WATTS BAR NUCLEAR PLANT (WBN) UNIT 1 - TECHNICAL SPECIFICATION
(TS) CHANGE NO. WBN-TS-99-014 - STEAM GENERATOR ALTERNATE REPAIR
CRITERIA FOR AXIAL OUTSIDE DIAMETER STRESS CORROSION CRACKING
(ODSCC) - RESPONSE TO REQUEST FOR ADDITIONAL INFORMATION - (TAC
NO. MA8635)

WATTS BAR NUCLEAR PLANT UNIT 1 PROPOSED TECHNICAL SPECIFICATION CHANGE WBN-TS-99-014 ALTERNATE REPAIR CRITERIA (ARC) PRESSURIZATION RATE ISSUE RESPONSE TO NRC REQUEST FOR ADDITIONAL INFORMATION

Figure 1: Repeat of Figure 3.8 of the TVA report.

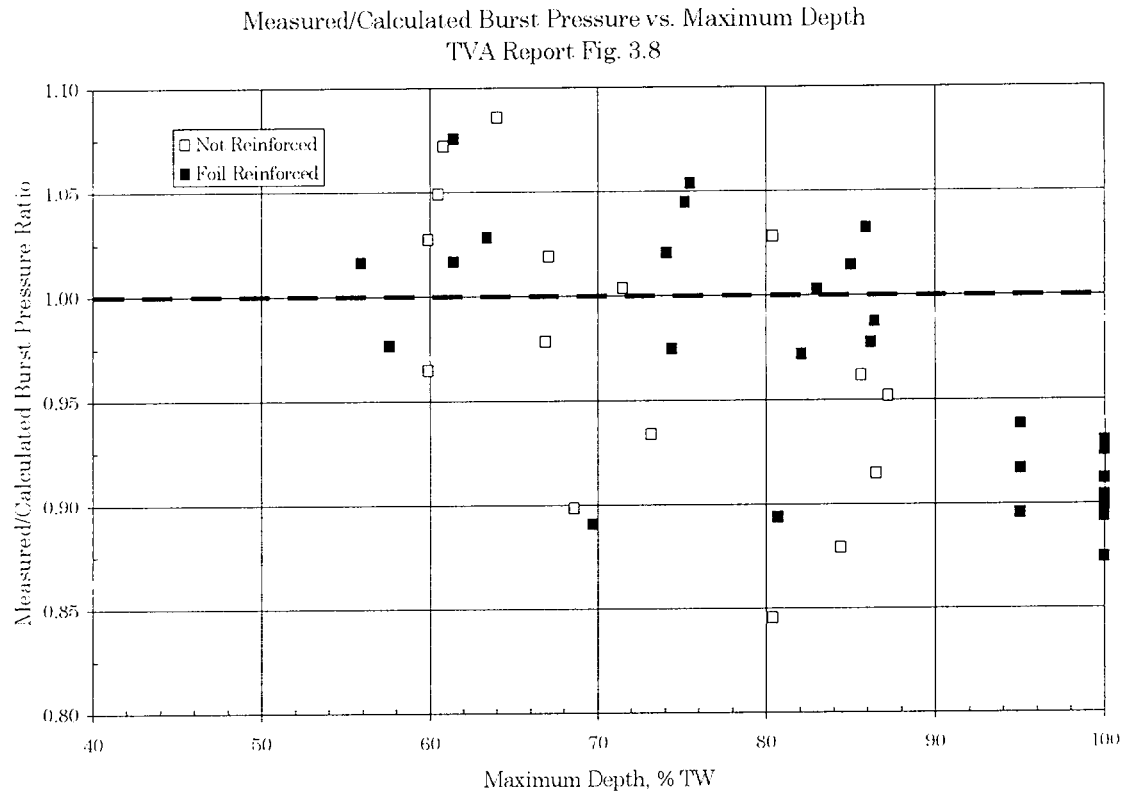
For Figure 3.8 of Enclosure 3, which was derived from Table 3-1, please address the following:

- a. For the indications with maximum depths between approximately 65% and 85%, the predictive model underpredicted the burst pressures for specimens tested without foil. In Enclosures 3 and 4, it was indicated that the Cochet equation may overpredict the burst pressure of partial through-wall cracks that do not end in full thickness material. In addition, it was indicated that the Cochet equation provides a conservative prediction of the burst pressure. Please address whether the underprediction for the 65% to 85% through-wall specimens tested without the foil is attributed to the limitations of the Cochet equation (related to cracks that do not end in full thickness material) or some other mechanism. If the underprediction is due to this effect, wouldn't it be more appropriate to compare the mean of the data for a specific depth (or a small depth range) for those specimens tested without a foil to the mean of the data for the same depth for those specimens tested with a foil to assess the effect of a foil for this specific geometry? If this were done, would it

alter the conclusion that a foil effect is being observed and/or its magnitude?

- b. Given the scatter in the burst pressure data for any given depth (approximately 5 to 10% in the burst pressure), discuss whether normalization of the data (to a mean curve) is appropriate and/or whether more testing needs to be performed to reach the conclusions drawn in the report.

- c. The staff notes that the tests depicted in Figure 3.8 were performed at slow pressurization rates and the tests indicating a foil effect were done at fast pressurization rates. These latter tests compared "fast-foil" tests to "slow-no-foil" and "fast-no-foil" tests. See Question 4.

A copy of Figure 3.8 is included as Figure 1 of this document. A review of the figure does effect a comparison of the means of the foil and no foil tests across the full range of depths. It is also apparent that there is a trend for the model to over estimate the burst pressure for the deeper specimens regardless of the presence of a foil reinforced bladder during the test, i.e., the data trend downward from left to right on the figure. A clearer comparison is apparent from an examination of Figure 3.7 of the report, which is included herein as Figure 2 for your convenience. Figure 2 illustrates the results from both models against an ideal prediction line and shows the results of performing a linear, 1st order regression analysis of the measured burst pressures on the predicted burst pressures. It is apparent from the figure that neither the slopes nor the intercepts are significantly different when separate regression analyses are performed for the no-foil and foil data.

The use of any normalizing equation leads to the conclusion that "the systematic deviation from the prediction model (Cochet or ANL) is the same for foil and no foil specimens." In other words, there is no detectable foil effect in the TVA specimens, and that finding extends to the ODSCC database because of the length of degradation involved.

It must be stressed that a comparison of the relative merits and or limitations of the normalizing equations, Cochet or ANL, is not relevant to this discussion, only that any systematic deviations of test data from the model used do not depend on whether or not the cracks or slots end in full thickness material. Because the trend of the data is consistent, it is not considered necessary to segregate the data into depth bands for comparison of foil and no-foil effects. This is supported by the information presented on the attached Figure 2.

The results of the tests were normalized using standard industry models, and thus could be concluded to have been normalized appropriately. The scatter of the data is not more pronounced than for other strength models employed, hence, more testing does not need to be performed to reach the conclusions expressed in the report.

The response to this issue is provided following Question 3 above. The important consideration here is with regard to the ODSCC ARC database, which consists of steam generator and laboratory tube cracked specimens with axial lengths and depths that in the extreme are comparable to the TVA test specimens. Results from "slow-foil" tests are not considered necessary to the resolution of the pressurization rate effect. Moreover, the test results for the TVA specimens demonstrate that any foil effect that might be implied by the results of the tests of the Type 14 specimens is not meaningful to the results of tube support plate ODSCC structural integrity tests.

Figure1: Pressure vs. time history for a different specimen.

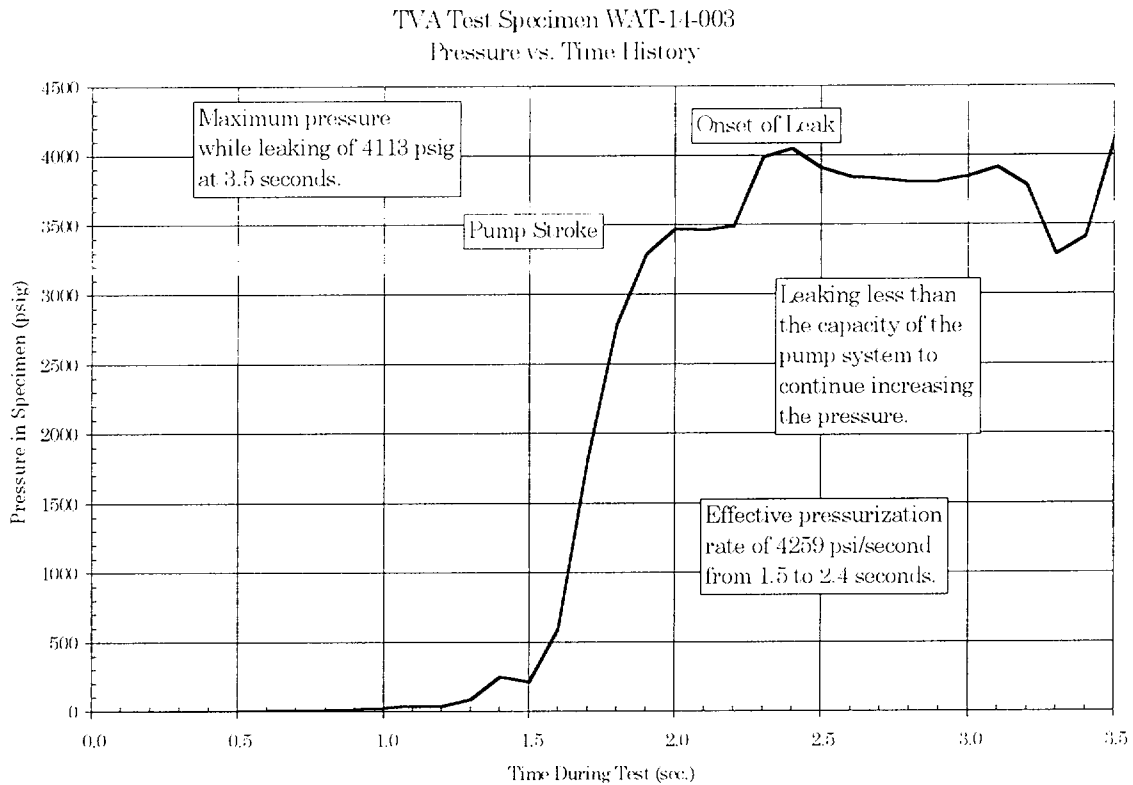
Figure 2.3 of Enclosure 3 represents a typical pressurization rate curve for the fast pressurization tests performed without the foil (this figure is actually a pressurization rate curve for a leak test). A review of this figure indicates that the pressurization rate prior to leakage was only on the order of 300 psi/sec rather than 2000 psi/sec. As a result, it appears to draw into question the conclusion that there is no pressurization rate effect. The subsequent test of this tube would have been performed with a bladder and a different flaw geometry.

The inclusion of the pressurization rate figure for specimen WAT-14-001 as typical was not intended to imply that the rates for the specimens were identical. In fact, the figure illustrates the rate for the slowest tested specimen. The data on the figure show that the overall average pressurization rate for the specimen was about 1191 pounds per square inch per second (psi/s), i.e., the pressure started to increase at 1.8 seconds and reached 4044 psi at 4.9 seconds. For the pressure range from 3500 to 4044 psi the rate was about 454 psi/s, the lowest pressurization rate of any of the Type 14 models tested. Table 2 in Enclosure 1 of this letter, provides a listing of the salient pressure and time information from the records for each of the Type 14 specimens. The average rate ranged from a low of 1191 psi/s to a high of 6472 psi/s. Also listed in Table 2 are the ratios of the measured maximum pressure to the predicted maximum pressure for each model, which demonstrates that the ratios were not dependent on the rate of the test, e.g., the fastest test had the lowest ratio. Figure 1 of this enclosure illustrates the pressure versus time history for a specimen that had an effective pressurization rate in excess of 4000 psi/s. Figure 2 of this enclosure illustrates the pressure versus time history for the

Figure 2: Pressure vs. time history for the specimen with the maximum rate.

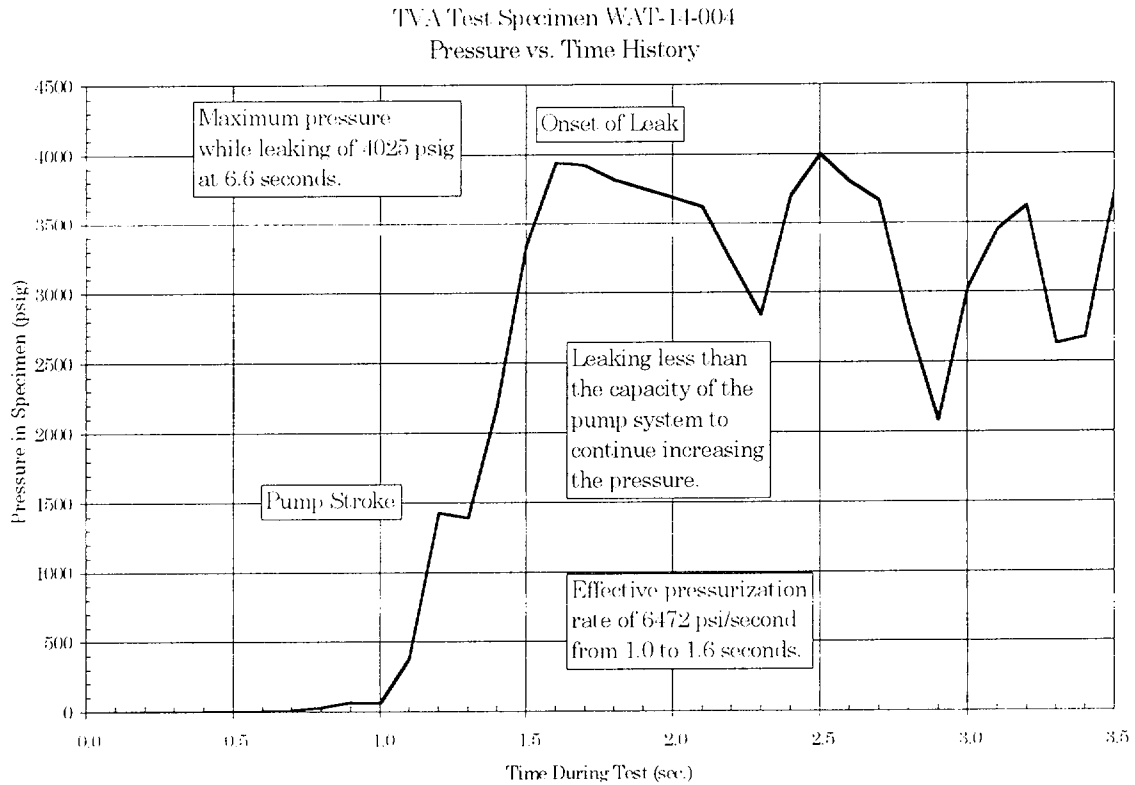
If the plot in Figure 2.3 is typical, it is not apparent that the results truly represent "fast pressurization rate tests without a foil" rather they may represent slow tests without a foil.

In light of the above, discuss the need to conduct slow pressurization rate tests with a foil so that a direct comparison of pressurization rates can be performed.

specimen tested at the fasted rate. For the specimens shown in these figures it should be noted that the rate near the end of the test was similar to the average rate during the whole test. Finally Figure 3 of this enclosure illustrates a chart of the onset-of-leak pressure as a function of the pressurization rate, convincingly showing that the pressurization rate did not influence the ligament tearing pressure of the specimens. The implication is that slow pressurization rate tests of specimens with a foil reinforced bladder liner are not needed.
